OFGEM

EDF (EPN)

**DPCR4 – FBPQ ANALYSIS AND
CAPEX PROJECTIONS**

DECEMBER 2004

Chart 2.1 - Medium & High Expenditure Scenarios

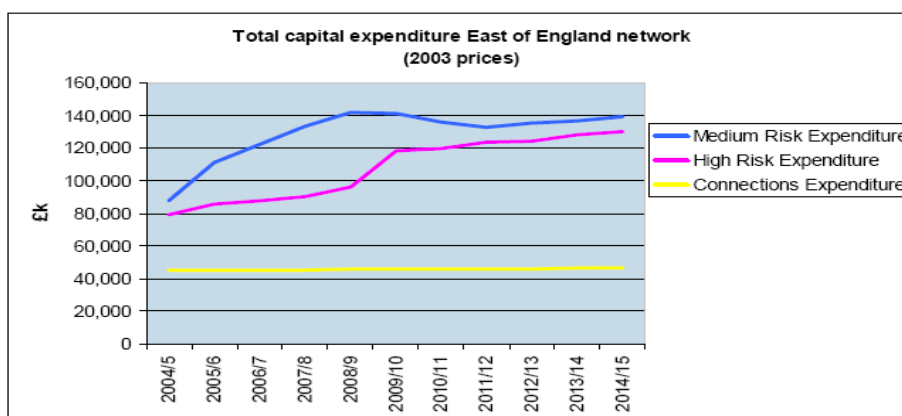
The shape of the above curves reflects that the 'ramp-up' of expenditure proposed under the 'medium risk' scenario has been advanced by 4 years with respect to the 'high risk' scenario. Neither expenditure profile represents a minimum capex projection required for the next regulatory period since both expenditure profiles are aimed at a reduced level of network risk below the current level. EDF quantify the level of risk as the number of substations overloaded above a certain percentage of time, 5% or 10%. Both scenarios tabled by EDF are intended to reduce or eliminate the number of substations that fall into one or other of the above categories. It may be that other substations will have higher loads than at present but they cannot go into the overload situation without impacting on the numbers that EDF say they are going to reduce and on this basis, the overall level of risk, as quantified and expressed by EDF will reduce.

Chart 2.2 - Reproduced from EPN NAMP Description of Work Programmes

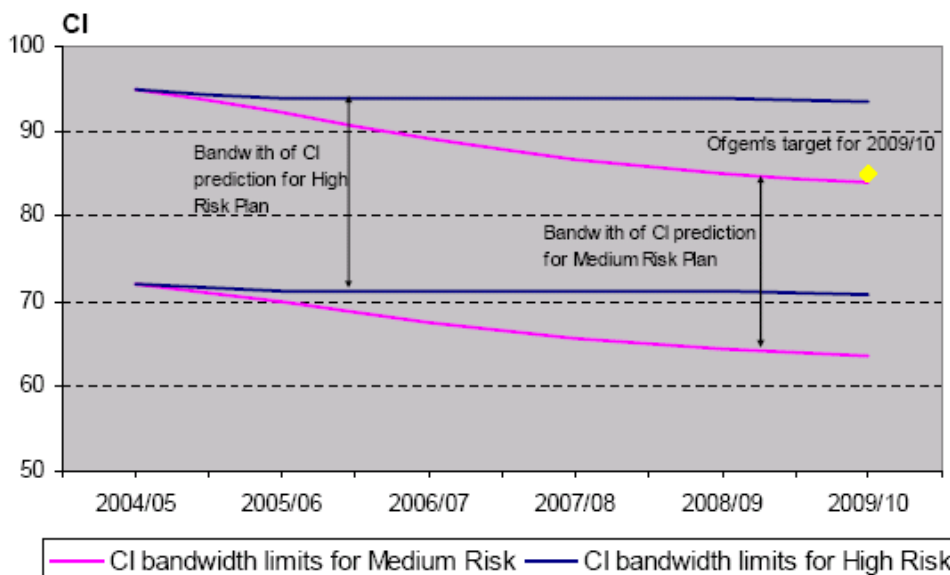
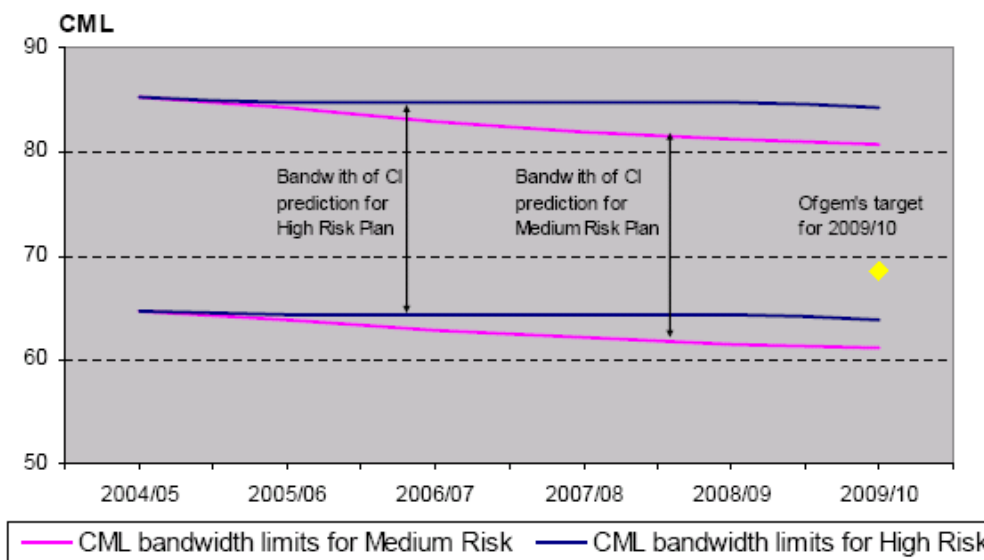
EDF have prepared graphs (in the NAMP Description of Work Programmes), reproduced below, showing how network performance is expected to improve as a result of the medium risk and high risk expenditure streams considered. It can be seen that the Ofgem Targets for 2010 lie comfortably within the range for the Medium Risk Investment Plan and less so for the Higher Risk plan.

EDF(EPN) consider that the performance achievable by 2010 by this expenditure cannot be further improved without the change of approach described under the QoS scenarios.

Figure 3.1 - Adjustment of Customer Numbers

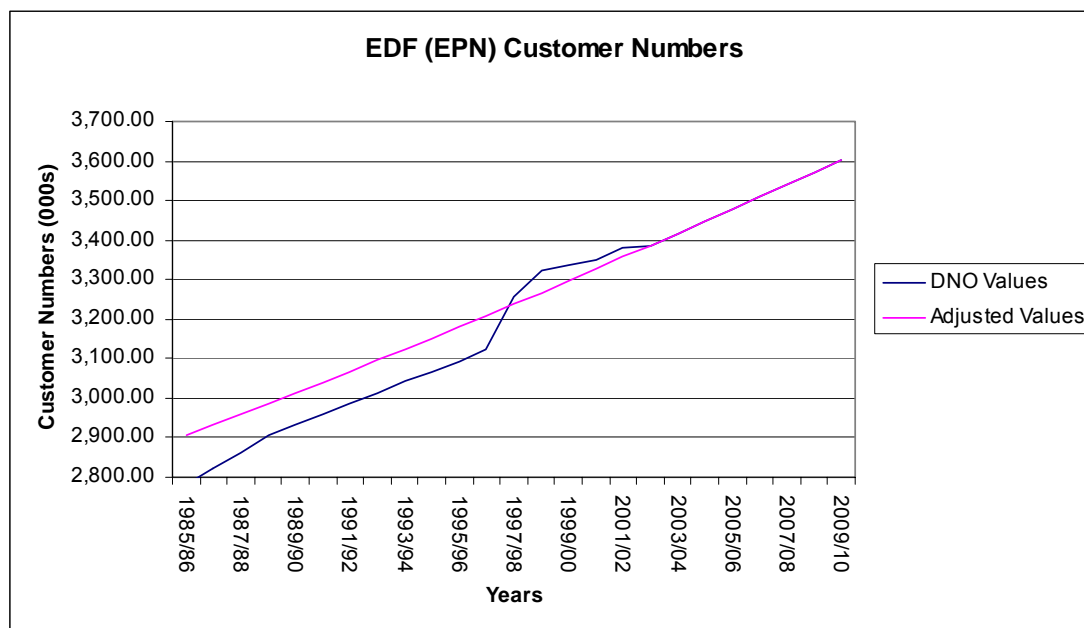
EPN's customer numbers have a significant step increase between 1997/98 and 2001/02. PB Power has removed this step by applying an average growth rate of 0.9% working back from 2002/03. The average growth rate has been calculated between 1989/90 and 1996/1997 and is similar to the forecast growth rate.
